Name of Applicant Type of Certificate	Proposal	Map/Plan Policy	Plan. Ref Expiry Date
<b>CALA HOMES “A”</b>	Submission of Reserved Matters to 11/0343 (internal access, appearance, layout, scale and landscaping) for the erection of 80 residential units (resubmission of 12/0066)	ADR TPO LBS	12/0586 10.10.12
	Land at Church Road, Catshill

**RECOMMENDATION:** that **RESERVED MATTERS** be **APPROVED**

## Revised Reserved Matters Application Scheme Plots 1-28 July 2012

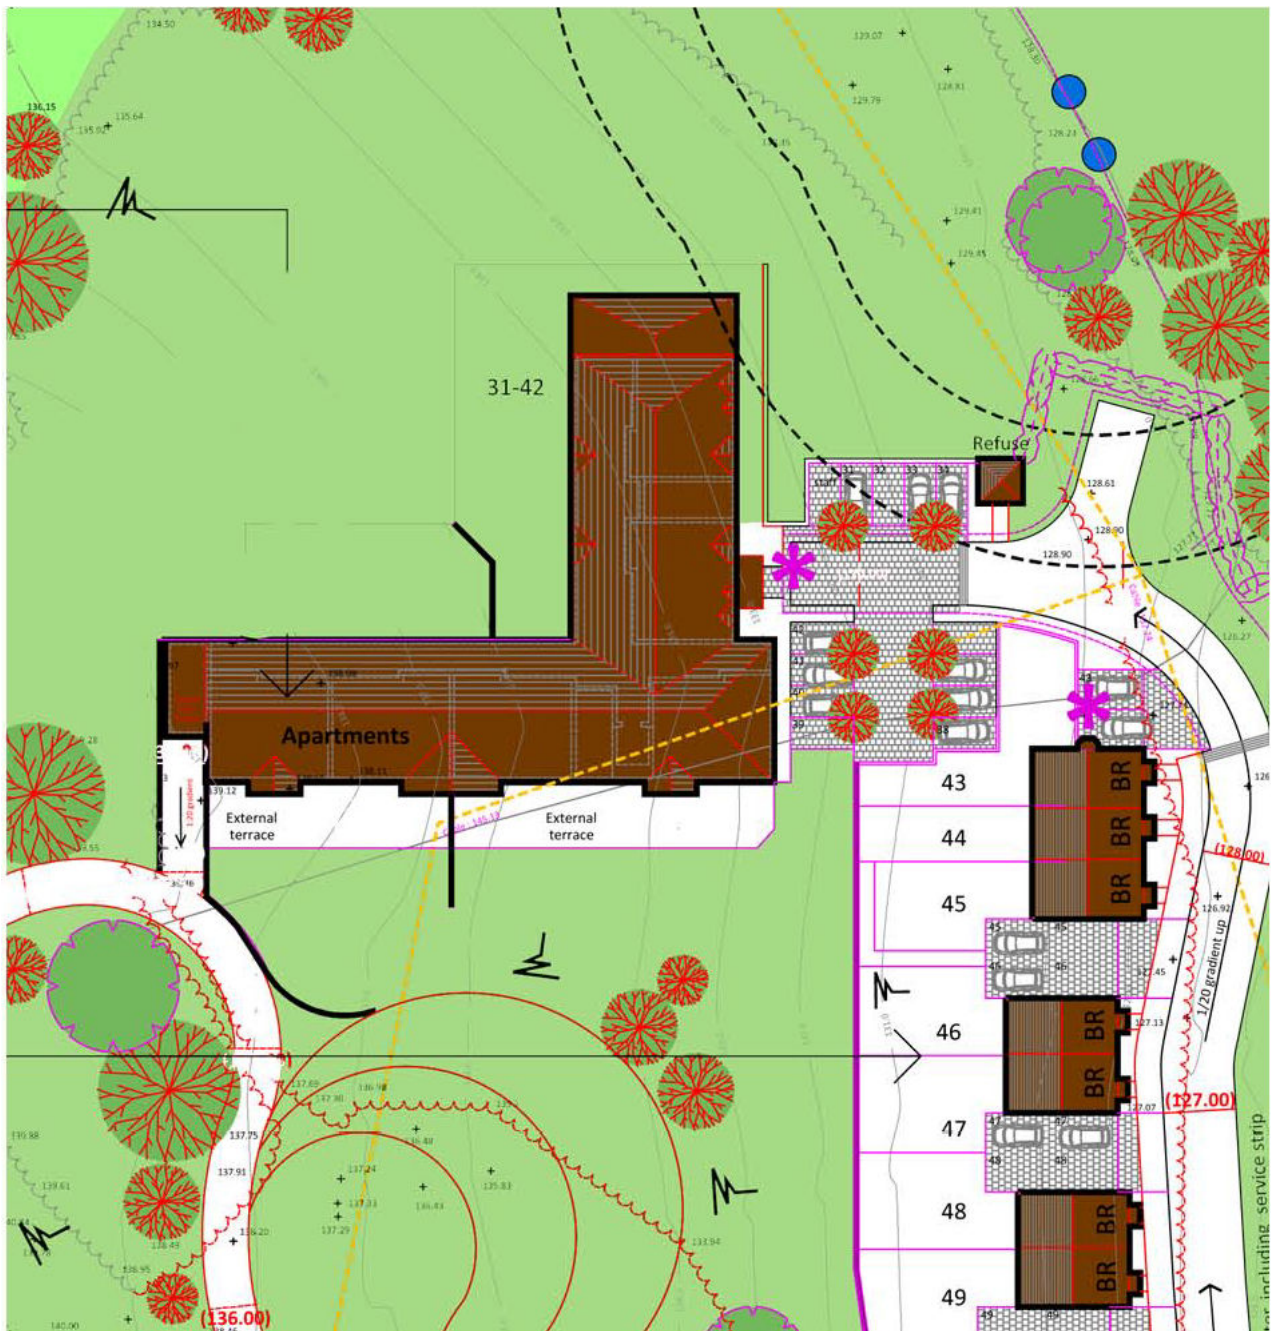
- The cluster of houses on the eastern side of the site has now been redesigned in the resubmitted scheme, and has returned approximately to the arrangement in the Indicative Layout Plan contained in the approved outline application, on which I earlier reported favourably. This is now acceptable.

- The distribution of the affordable properties, both in this cluster (the north-east boundary) and more generally, appears to be more equitable than previously.

In response to the reasons for refusal the general arrangement of houses has been reconsidered in relation to the sewers, and the buildings realigned to break up the long terrace of houses and better relate to the outline indicative scheme.

The constraints imposed by the sewers have been reviewed and engineering solutions reappraised. The resulting layout has been improved by breaking up the terraces and presenting a scheme that follows more closely the design principles set out in the outline approval. The Urban Designer views the revised configuration to be acceptable and raises no issue on this aspect of the amended scheme.
